ARCHITECTURAL ASSESSMENT & PLANNING STRATEGY REPORT

Technical Guidance for Photoshop Update & Council Compliance Alignment

Project Site:	11 Eastcheap, Letchworth Garden City, SG6 3DA	Date:	08 June 2026
Authority:	Letchworth Local Planning Authority / Heritage Foundation	Document Ref:	ARCH-ONCU-PL02
Status:	Extension Agreed to 05.06.2026 (Live Framework)	Prepared By:	Architectural Advisory & Compliance

Figure 1.1: Unmodified Reference Plan Sheet (25.01-D1)

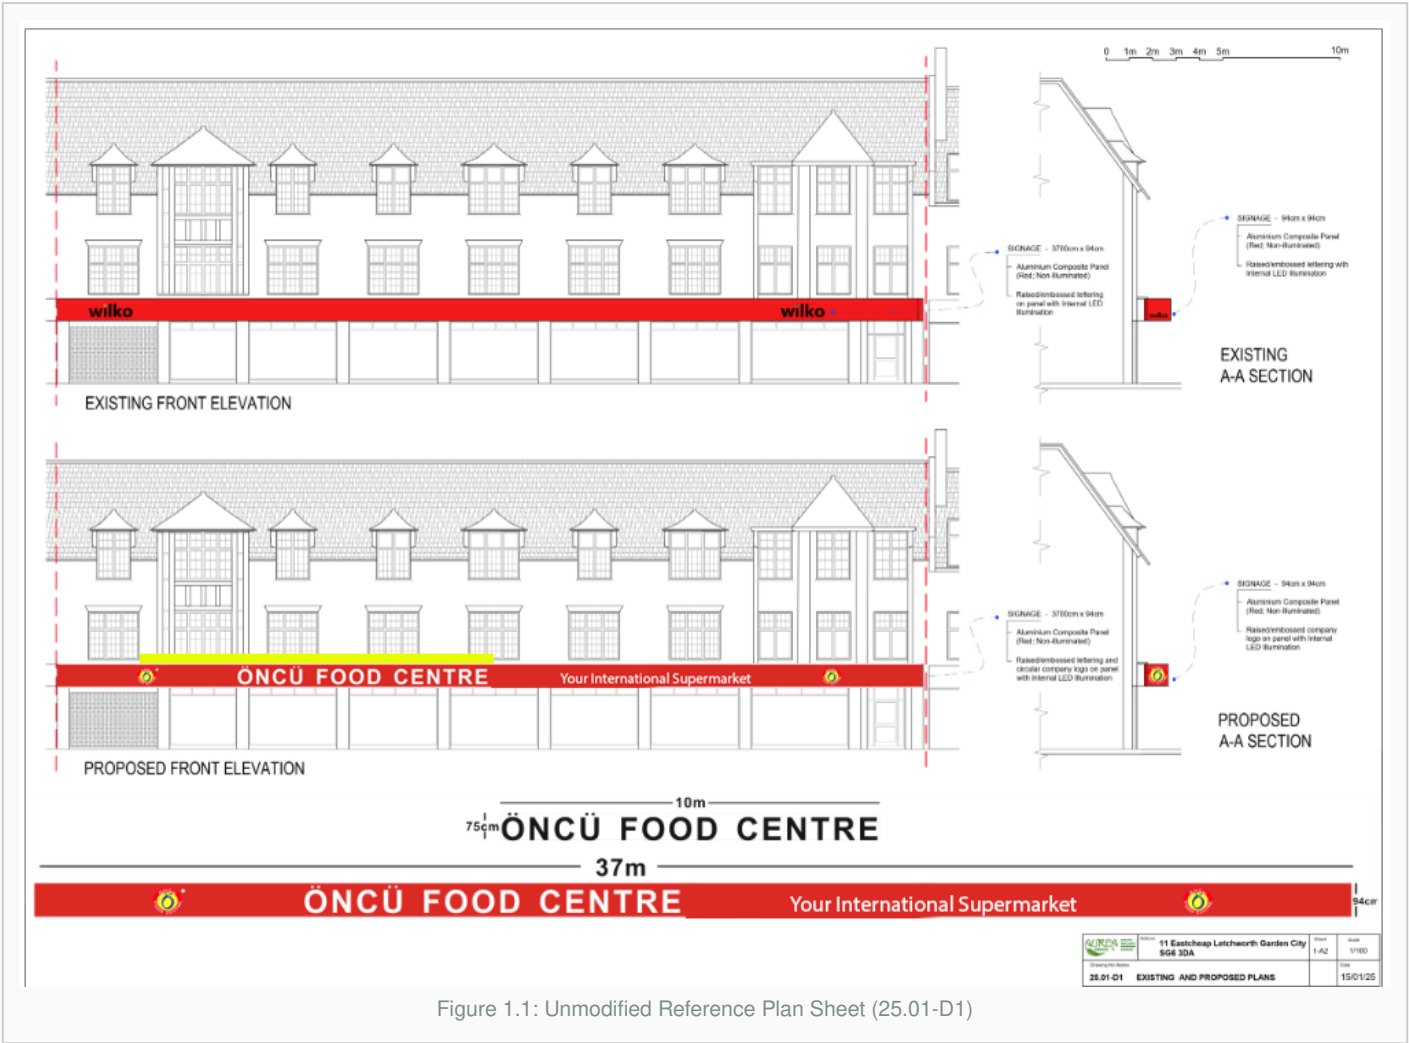
Drawing Section	Officer Deficiency & Requirement	Actionable Photoshop Modification
Main Fascia Overlay (Lower Section)	The Case Officer strictly forbids placing text measurements directly across the graphical fascia artwork face. All arrows, text tags, and indicators must be cleared from the signage profile to preserve architectural drafting aesthetics.	• Cleanly erase the "37m" text and horizontal arrows from the face of the long red banner. • Cleanly remove the "10m" line and text indicator. • Wipe out the "75cm" text tag completely.
Proposed A-A Section (Right Column)	The projection sign box on the "Proposed A-A Section" diagram currently renders blank without identity graphics, creating a structural contradiction in the documentation.	• Copy the circular yellow and red Öncü Logo Emblem. • Scale down and cleanly insert it inside the small square projection sign on the PROPOSED A-A SECTION drawing.

External Illumination (Yellow Accent Strip)	The bright yellow strip drawn above the lettering specifies external illumination, but the sheet completely lacks any contextual descriptive callouts or labels defining its physical electrical engineering characteristics.	• Keep the yellow line profile exactly as it is. • Add a fine pointer line extending from the yellow strip to the side margin with the text label: <i>"Proposed continuous external linear LED strip light bar (3000K Warm White Downlight)."</i>

To satisfy the Case Officer's mandate ("*Any markings should be placed as a note on the side, not on the signage itself*"), the cleared metrics must be typed onto the right-hand blank margins using a clean sans-serif typeface.

- Total Continuous Length: 37.00 Metres (37m)
- Vertical Panel Uniform Height: 0.94 Metres (94cm)
- Text-to-Panel Ratio: Lettering scales within a maximum 12.5% framework height threshold.

- **External Illumination:** Continuous top-lip external overhead linear LED light bar track. 3000K static light output restricted to ≤ 600 cd/m² maximum brightness.
- **Projecting Signage:** 94cm × 94cm square layout. Double-sided architectural aluminum frame with internal static LED array system restricted to ≤ 400 cd/m². Centered company roundel emblem on both faces.
